Access Compliance Report

Public Rights-of-Way

(Curb Ramps)

Intersection ID: 50335	Main Street: MILLIE_LN	Cross Street: LEVY_WY	Location: SW
ADA ID: 5DC6AFBB34D7	Ramp Type: PerpDiag	Initial Pass/Fail: Fail	Overall Compliance: No
Codes/Mitigation Info/Possible Solution		Field Measurements/Component Compliance	
Severity Score: 33.75

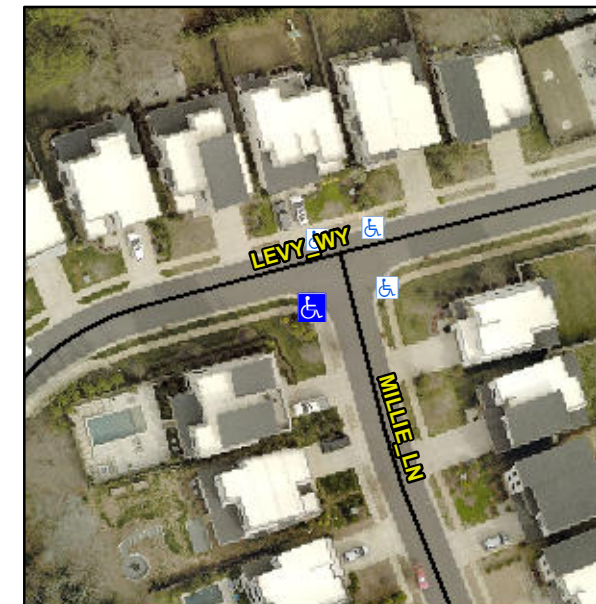
Not Found, R304.5.1, R304.2.2, R304.5.3

Compliance	Description	Data	Compliance	Description	Data
N/A	Ramp Length (in)	49.0	No	Ramp Slope (%)	9.8
No	Ramp Width (in)	45.5	No	Ramp XSlope (%)	6.7
N/A	Flare Type LT	N/A	N/A	Flare Type RT	N/A
N/A	Flare Slope LT (%)	N/A	N/A	Flare Slope RT (%)	N/A
N/A	Flare Traversable LT?	N/A	N/A	Flare Traversable RT?	N/A
N/A	Landing Length (in)	N/A	N/A	DWS Provided?	N/A
N/A	Landing Width (in)	N/A	N/A	DWS Contrast?	N/A
N/A	Landing Slope (%)	N/A	N/A	DWS Length (in)	N/A
N/A	Landing X Slope (%)	N/A	N/A	DWS Full Width?	N/A
N/A	Landing Curb? (Y/N)	N/A	N/A	DWS Offset (in)	N/A
N/A	Shared Landing?	N/A			
N/A	Gutter Ponding?	N/A	N/A	Gutter Slope (%)	N/A
N/A	Gutter Lip Ht (in)	N/A	N/A	Gutter X Slope (%)	N/A
N/A	Painted X Walk1?	No	N/A	Painted X Walk2?	No
	X Walk 1 Direction	To E		X Walk 2 Direction	To N
N/A	X Walk 1 Width (in)	N/A	N/A	X Walk 2 Width (in)	N/A
	X Walk 1 Slope (%)	3.4		X Walk 2 Slope (%)	2.1
	X Walk 1 X Slope (%)	2.9		X Walk 2 X Slope (%)	4.2

Remove & Replace Curb Ramp With Two New Directional Ramps or Equivalent.
